SERVICE LETTER June 06-2005

This Service Letter is for adding a placard beside each wing tank filler neck and for adding a fuel indicator tab to filler at wing fuel tanks. When filling each tank up to the tab, there is approximately 10 USG per tank.

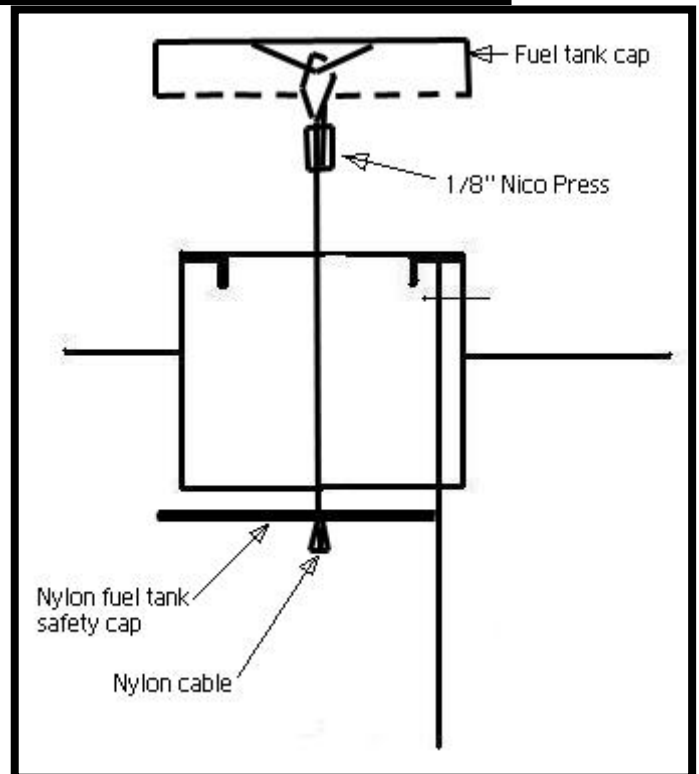
Note that nylon fuel safety cap must be attached to fuel tank filler cap when filling fuel past bottom of fuel tab.
